Remote Control Handle Change - P/N 92744A2

Replacement curved handle P/N 92744A2 for 88688A-- Console Remote Control.

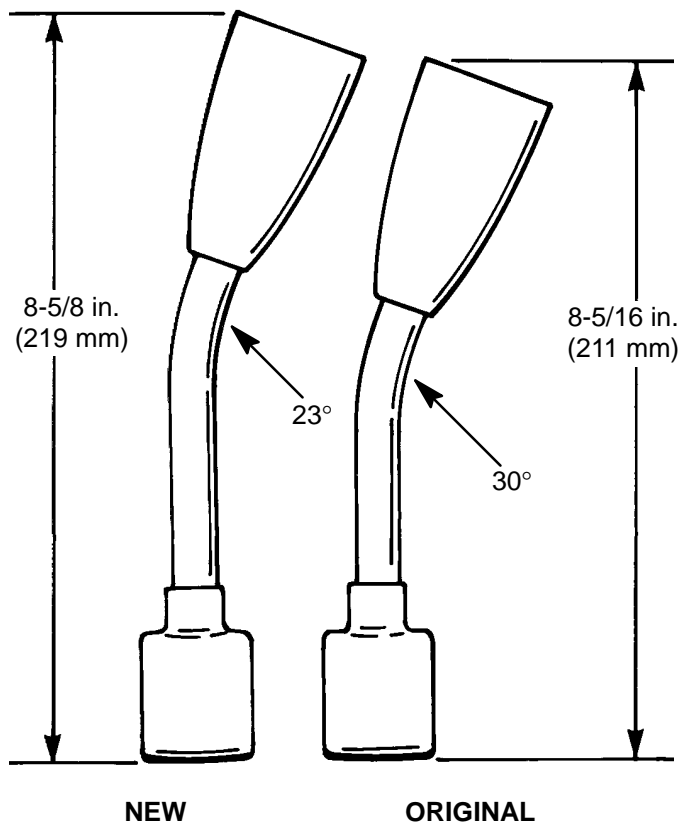
The original 30° bend replacement handle installed on the remote controls listed is not available. A new replacement 23° bend handle is available and is slightly taller than the original one. On Dual Console Controls, you may want to change both handles so they are the same height. The part number for the new handle is the same as the original handle part number.
